ORDINANCE NO. 2159

AN ORDINANCE OF THE TOWN COUNCIL OF THE TOWN OF HIGHLAND PARK, TEXAS, AMENDING THE CODE OF ORDINANCES OF THE TOWN OF HIGHLAND PARK, TEXAS, BY AMENDING CHAPTER 3, BUILDING REGULATIONS, BY AMENDING ARTICLE 3.02, BUILDING CODE; ARTICLE 3.04, PLUMBING, DIVISION 2, PLUMBING CODE; ARTICLE 3.05, GAS CODE; ARTICLE 3.06, MECHANICAL CODE; ARTICLE 3.07, ENERGY CONSERVATION CODE; ARTICLE 3.08, RESIDENTIAL CODE; AND ARTICLE 3.18, SWIMMING POOL AND SPA CODE; ALL FOR THE PURPOSE OF ADOPTING THE 2024 EDITIONS OF SUCH INTERNATIONAL CODES AND LOCAL AMENDMENTS THERETO; AND BY AMENDING ARTICLE 3.03, ELECTRICITY, DIVISION 2, ELECTRICAL CODE FOR THE PURPOSE OF ADOPTING THE 2023 EDITION OF SUCH INTERNATIONAL CODE AND LOCAL AMENDMENTS THERETO; AND BY AMENDING ARTICLE 3.15, PERMIT APPLICATION REVIEW PROCEDURES AND VESTED RIGHTS DETERMINATIONS, TO UPDATE REFERENCES TO ADOPTED INTERNATIONAL CODES; PROVIDING FOR THE INCORPORATION OF RECITALS; PROVIDING A SEVERABILITY CLAUSE; PROVIDING A REPEALER CLAUSE; PROVIDING FOR INCORPORATION INTO THE CODE OF ORDINANCES; AND PROVIDING FOR AN EFFECTIVE DATE

R325.2 Bathrooms, Exception; amend to read as follows:

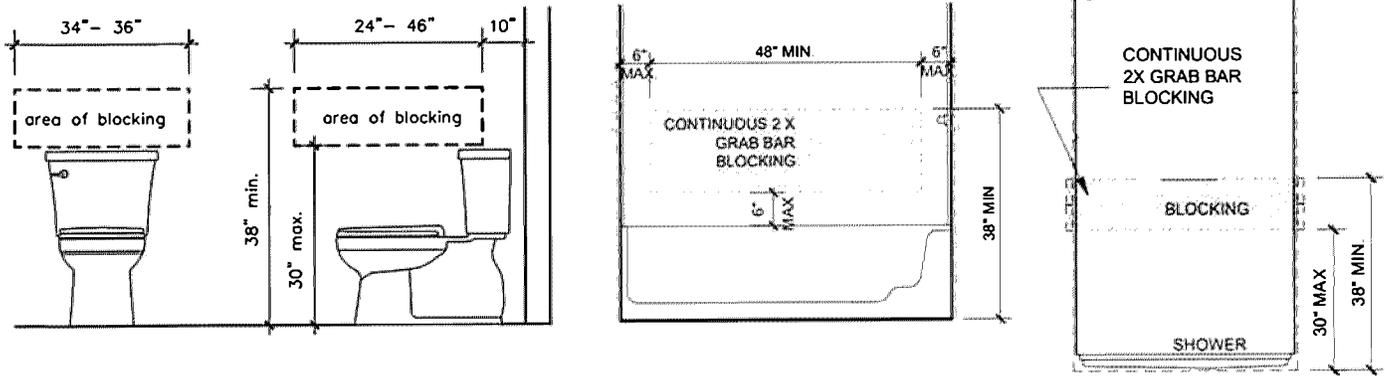
Exception: {existing text unchanged} Spaces containing only a water closet or water closet and a lavatory may be ventilated with an approved mechanical recirculating fan or similar device designed to remove odors from the air.

Fig R327.4

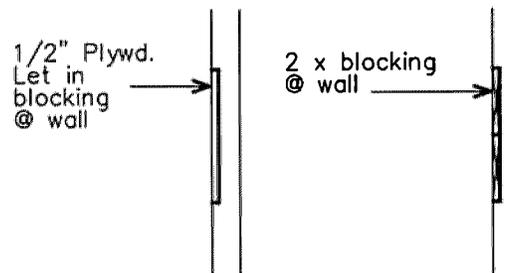
R327.4 Wall Blocking; add to read as follows:

R327.4 Wall Blocking: Blocking may be 1/2" plywood or 2 x solid wood blocking or equivalent, flush with wall as shown in Figure R327.4.

****Figure R602.6.1; delete the figure and insert the following figure:**

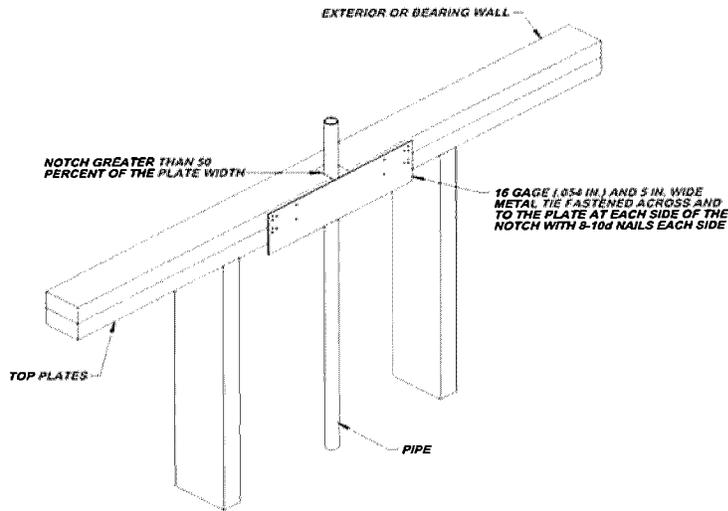
R602.6.1 Drilling and notching of top plate. When piping or ductwork is placed in or partly in an exterior wall or interior load-bearing wall, necessitating cutting, drilling or notching of the top plate by more than 50 percent of its width, a galvanized metal tie not less than 0.054 inch thick (1.37 mm) (16 Ga) and ~~1 1/2 inches (38) mm~~ 5 inches (127 mm) wide shall be fastened across and to the plate at each side of the opening with not less than eight 10d (0.148 inch diameter) having a minimum length of 1 1/2 inches (38 mm) at each side or equivalent. Fasteners will be offset to prevent splitting of the top plate material. The metal tie must extend a minimum of 6 inches past the opening. See figure R602.6.1. {remainder unchanged}
